**FILE** P.I. # 0012601 **OFFICE** Design Policy & Support  
Cherokee County  
GDOT District 6 - Cartersville **DATE** 8/5/2015  
CR 1874/Canton Road from  
Cobb County Line to CR 585/Stockwood Drive  
Pedestrian Enhancement

**SUBJECT** APPROVED CONCEPT REPORT

**DEPARTMENT OF TRANSPORTATION  
STATE OF GEORGIA  
LIMITED SCOPE PROJECT CONCEPT REPORT**

**Project:** Canton Road Sidewalk  
PI #0012601-Cherokee  
**Meeting:** Concept Team Meeting  
**Prepared By:** Ken D. Timpson, PE  
**Prepared On:** May 13, 2015

**TYPICAL SECTIONS**

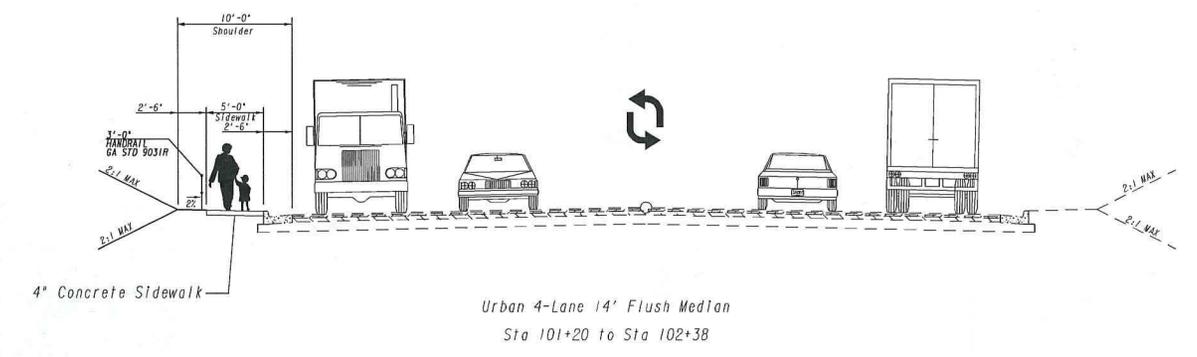
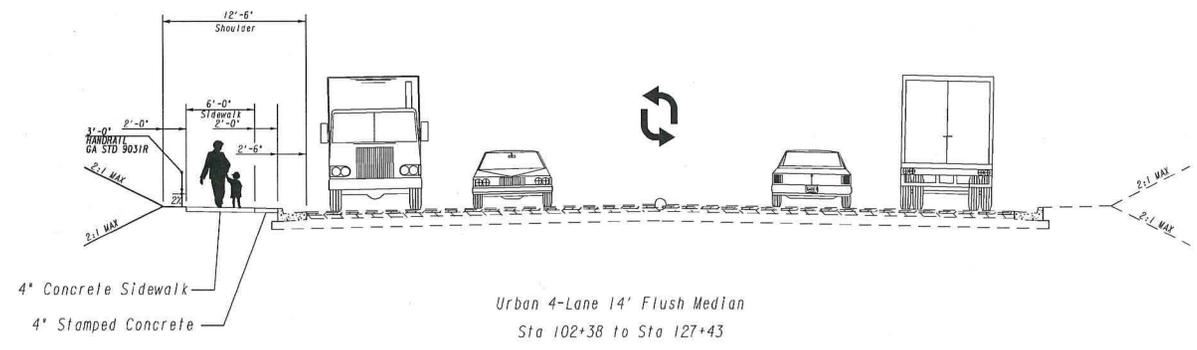
- Page 6 – Change the number of estimated property impacts to 15 in the Alternatives Discussion.
- Tim Matthews asked that we include the following:
  - Typical sections showing sidewalk against curb and a 10' shoulder.

- Correct the proposed typical section to show a 12.5' shoulder.
  - Take out the Liquid Asphalt Cost from the cost estimate, not needed on projects with less than one year of construction schedule.
